**ADDENDUM B – March 28, 2019**

This Addendum forms part of the Contract Documents and modifies the Construction Documents dated March 8, 2019, with amendments and additions noted below, for the Patio Roof Replacement at the Ocean Avenue LEARNing Academy, Ocean Avenue, New London, CT.

5. **R1.03 ROOF SECTIONS AND DETAILS:** Drawing reissued to provide additional information for railing assembly.

**B12 METAL RAILING SOUTH ELEVATION**  
1/4" = 1'-0"

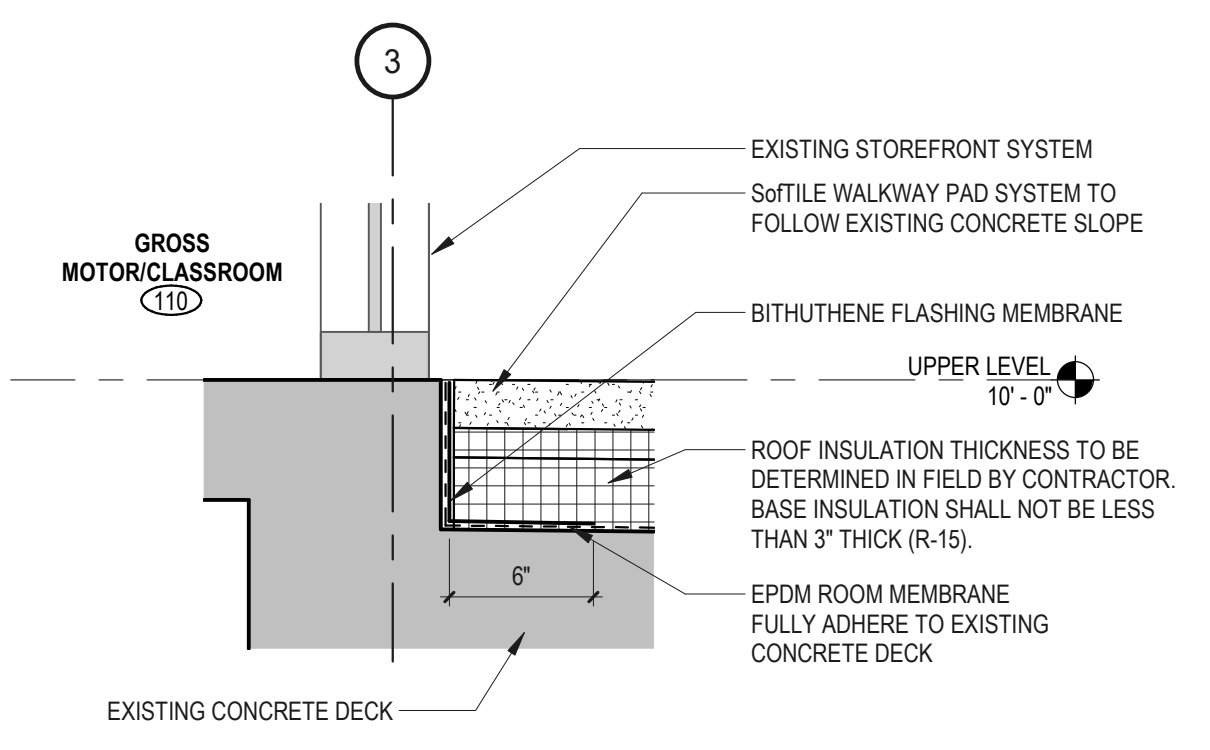
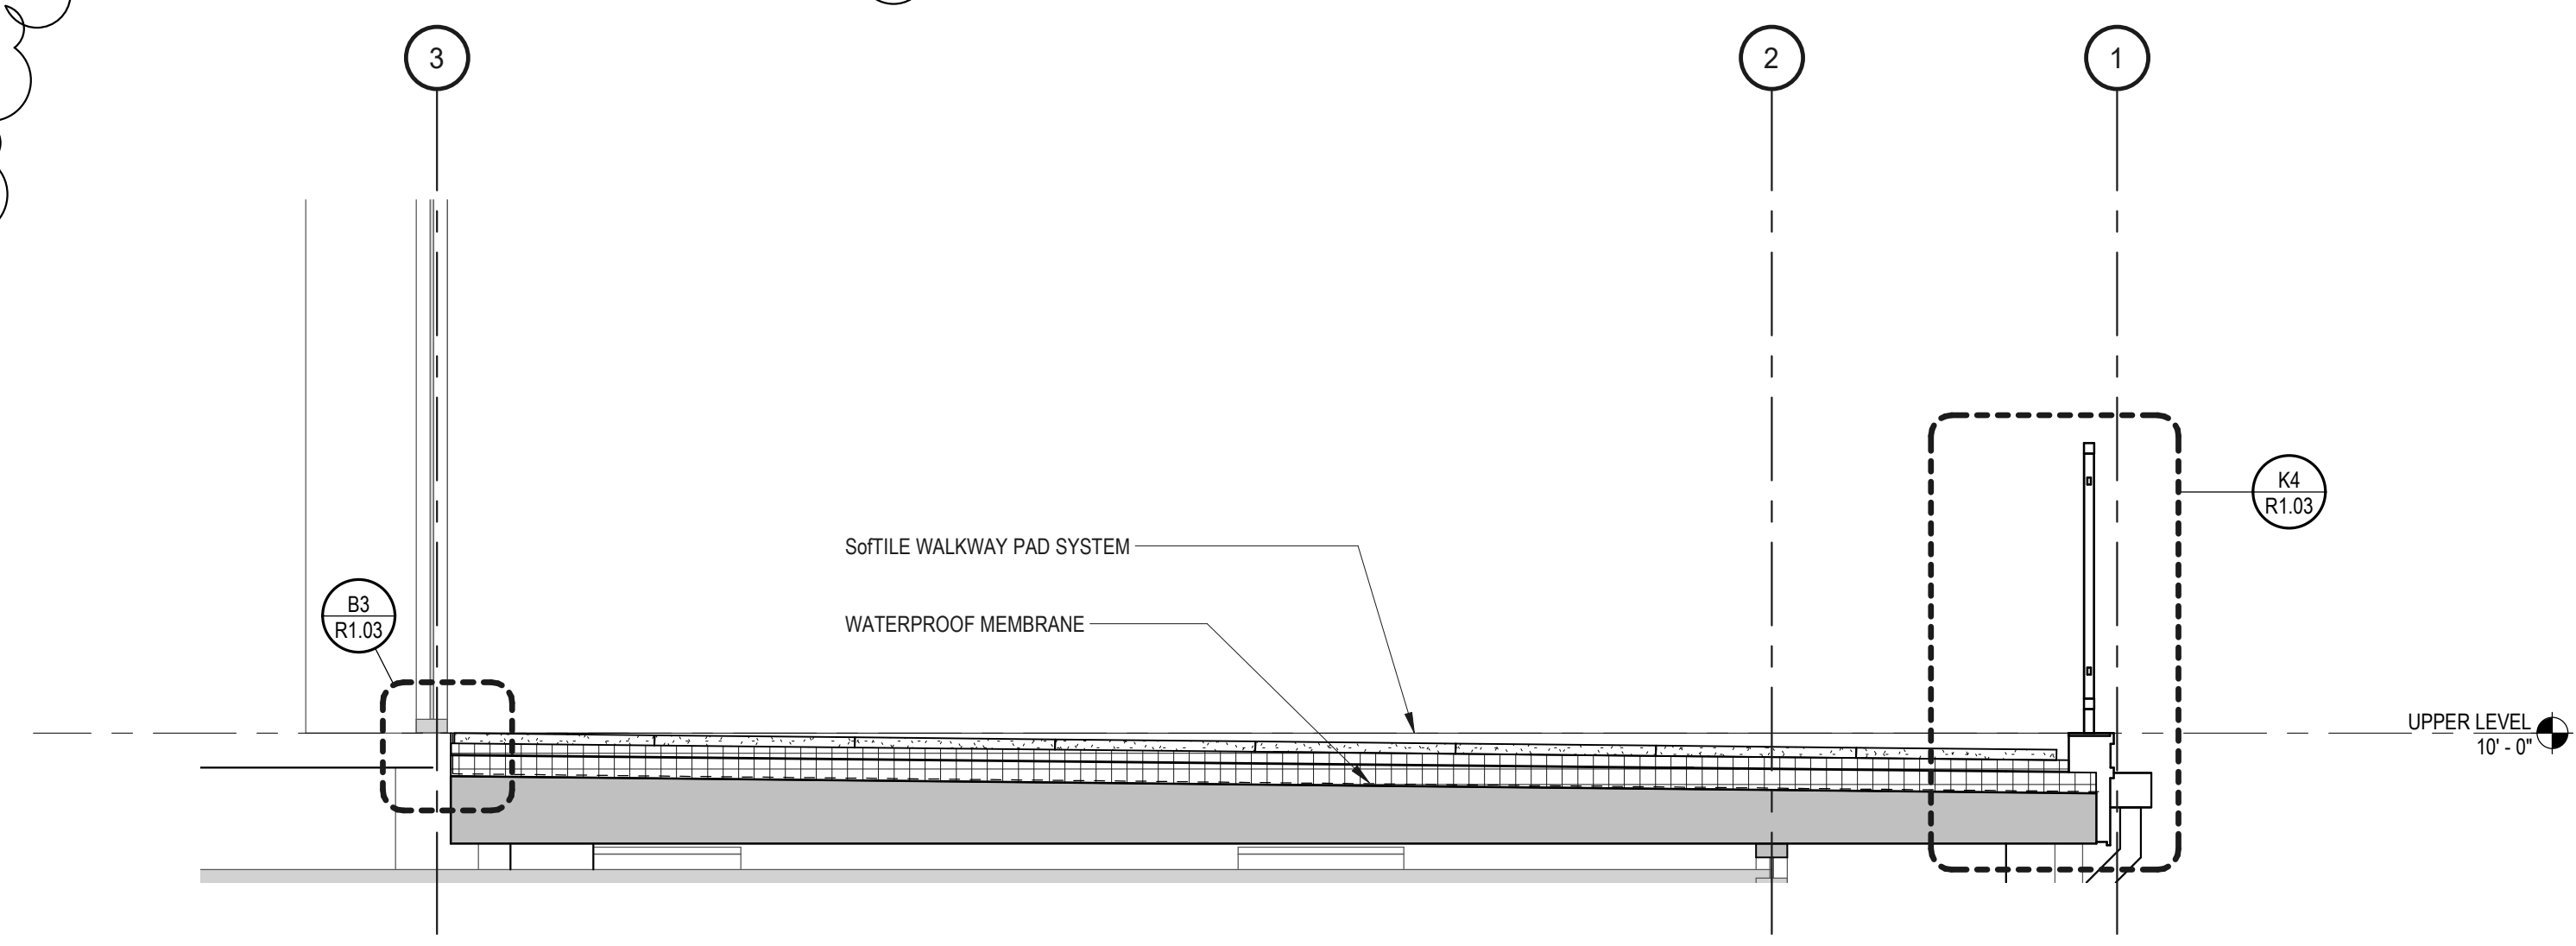
- a. **Answer:** No. Owner will be responsible to testing and removing ACM.
29. **Question:** Please provide an Elevation of New Railing System indicating Post Spacing and a Detail of typical Post Mounting requirements. Details shown on R1.03 and specifications do not provide adequate information for misc. metals sub-contractor to price out.

- a. **Answer:** Post spacing to be 4' on center maximum, refer to revised sheet R1.03.
30. **Question:** There is a note on R1.02 that indicates to "install new metal flashing along wall where former flashing was removed". Typical Rising Wall Detail B3/R1.03 does not show any new or existing Metal counter flashings?

**E5 PATIO ROOF SECTION**  
1/2" = 1'-0"

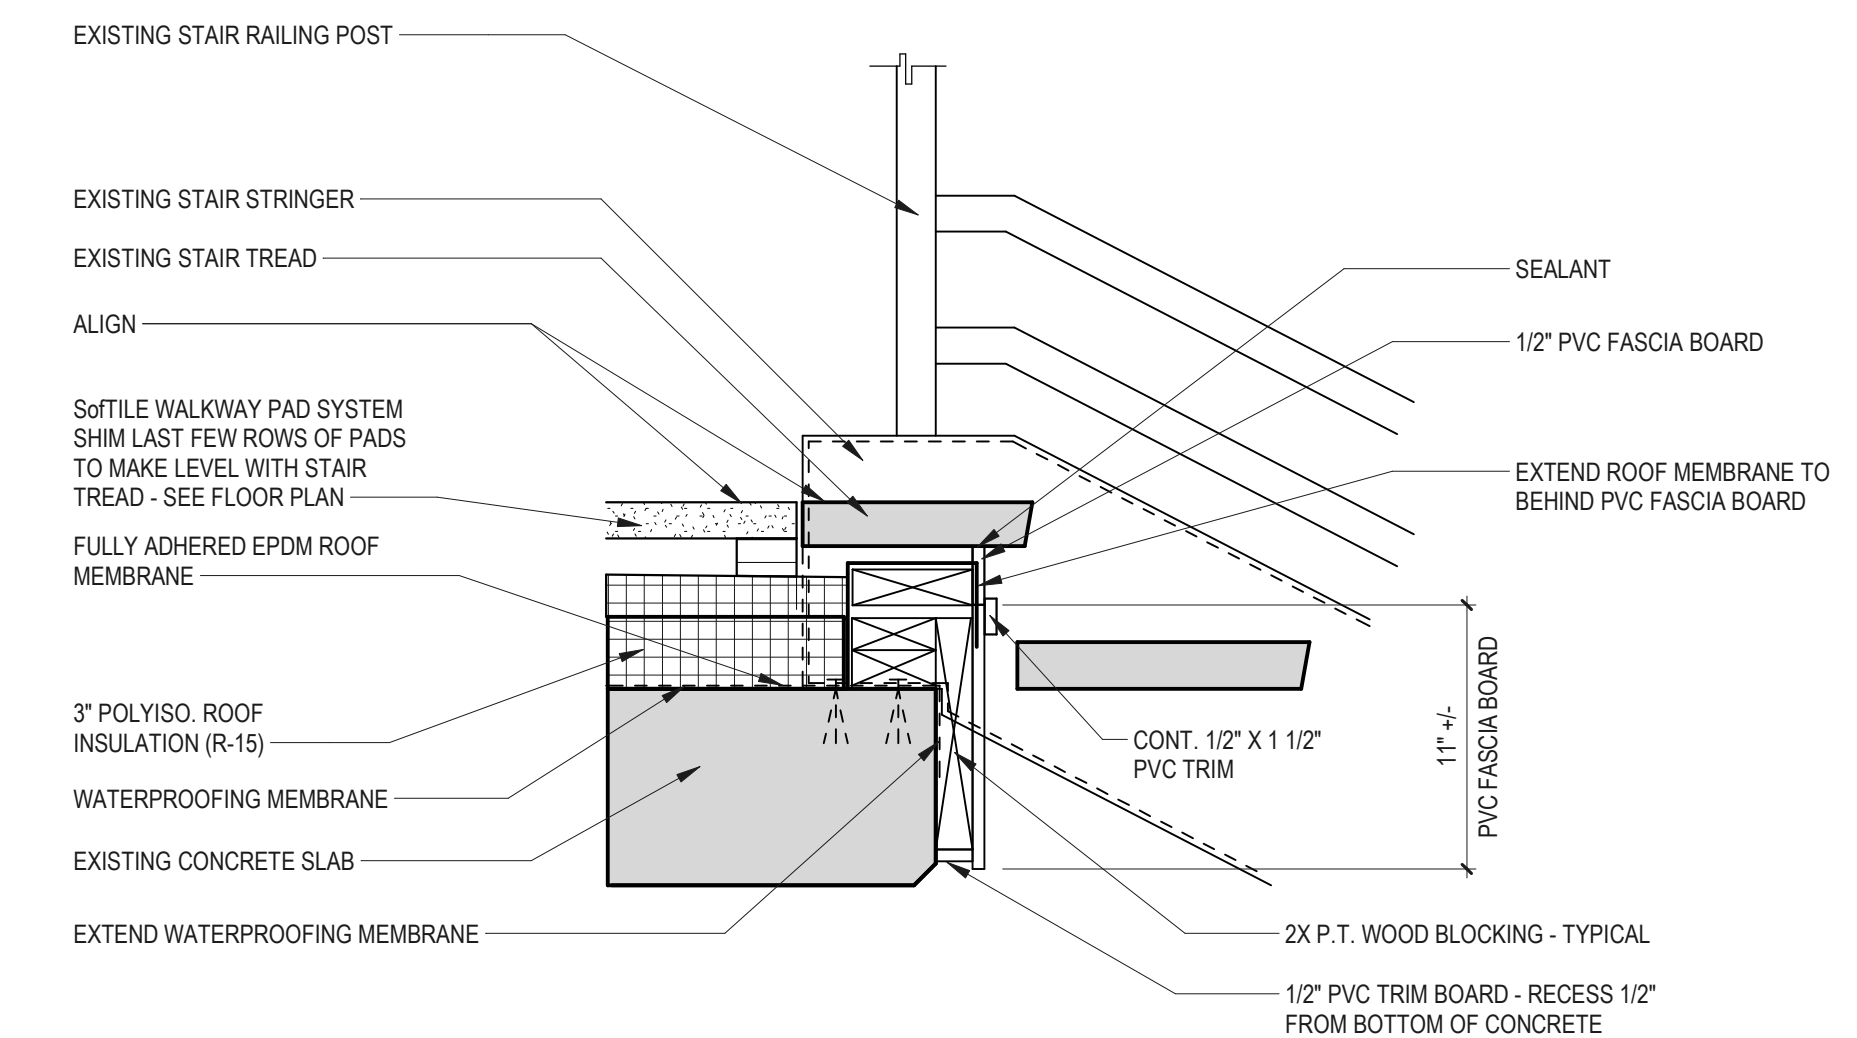
- a. **Answer:** (1) Color will be selected from manufacturer's standard color line.
22. **Question:** E5/R1.03 AT Storefronts=Looks like we have 6" from Structural Deck to Fin Top of Paver/Fin Floor- The code is R30 and you are showing R15 or 4" of insulation and then Softiles (2") directly on insulation-correct/Please advise?

- a. **Answer:** The intent of roof replacement is to replace the existing insulation R-Value in-kind.
23. **Question:** The intent is to put 4" of insulation on the existing slab (no tapered) correct?

**K11 SECTION DETAIL @ EXISTING TOP STAIR TREAD**  
1 1/2" = 1'-0"

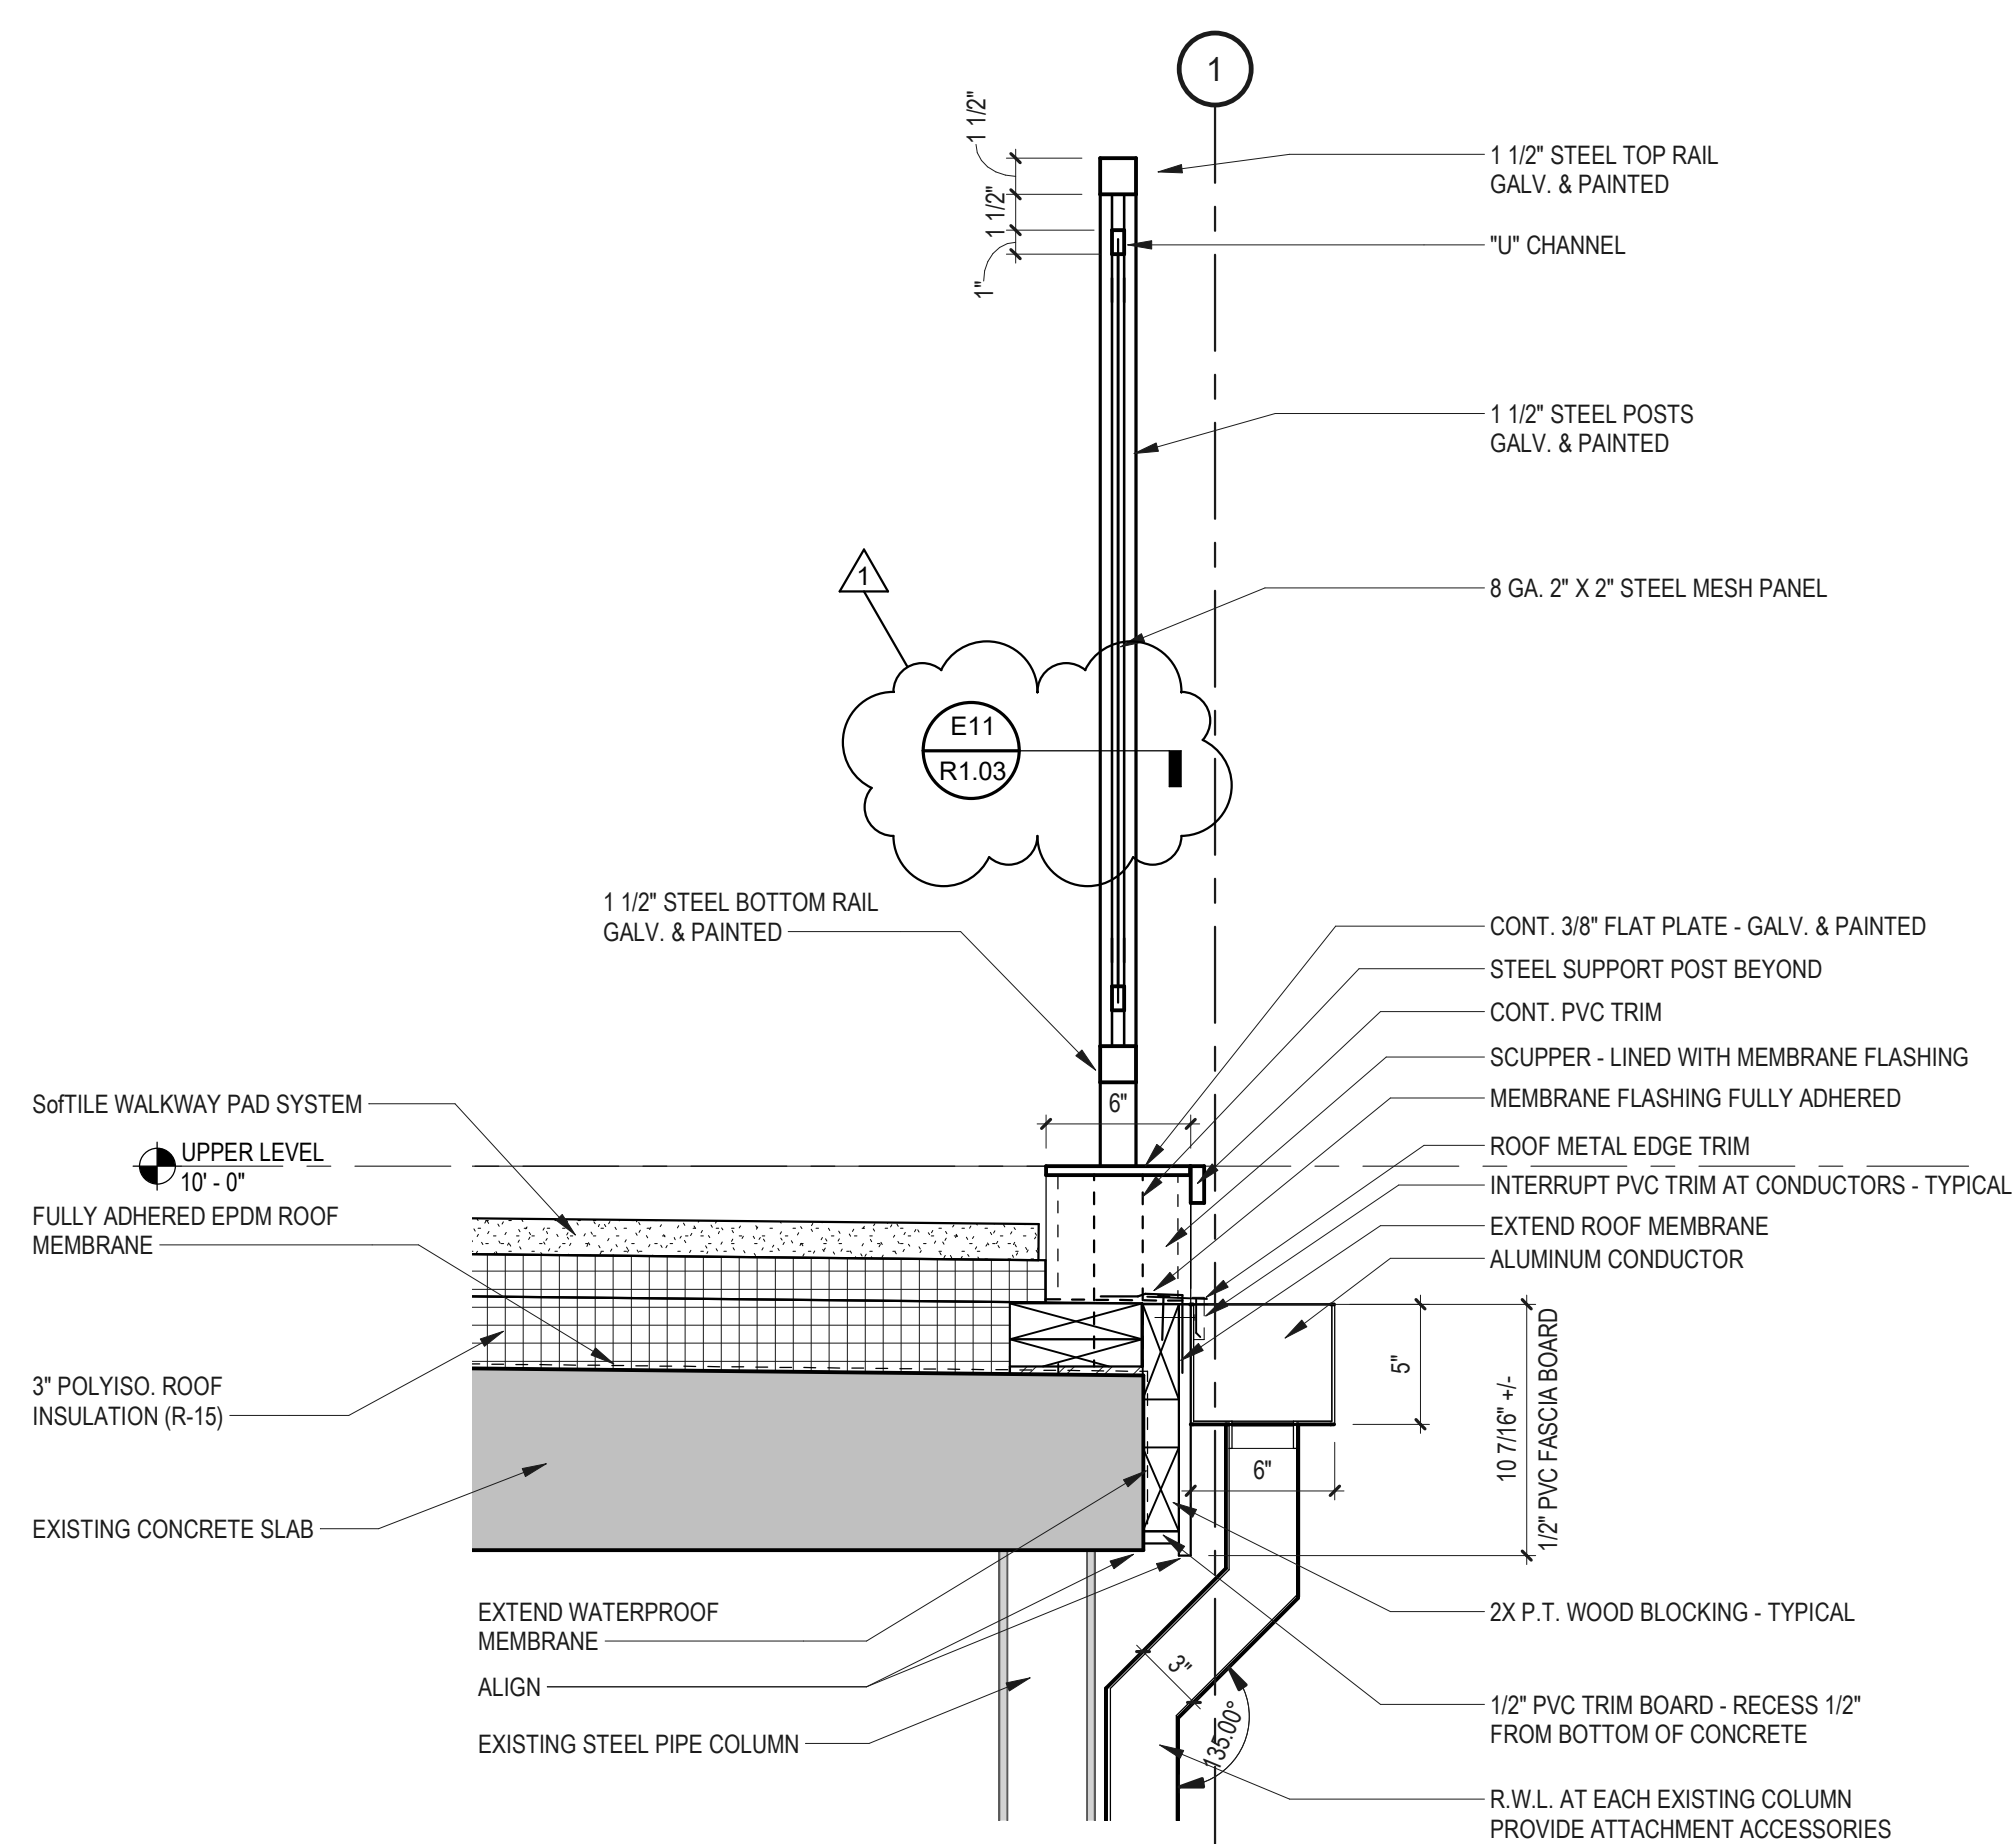
a. **Answer:** One paint color will be selected to match existing painted trim.
  19. **Question:** K3/R1.01 Estimators are asking how to seal EPDM to existing stair/Stringer?

a. **Answer:** Refer to detail K11/R1.03. Fully adhere roof membrane around stringers. Provide any required membrane flashing to insure a weathertight installation.
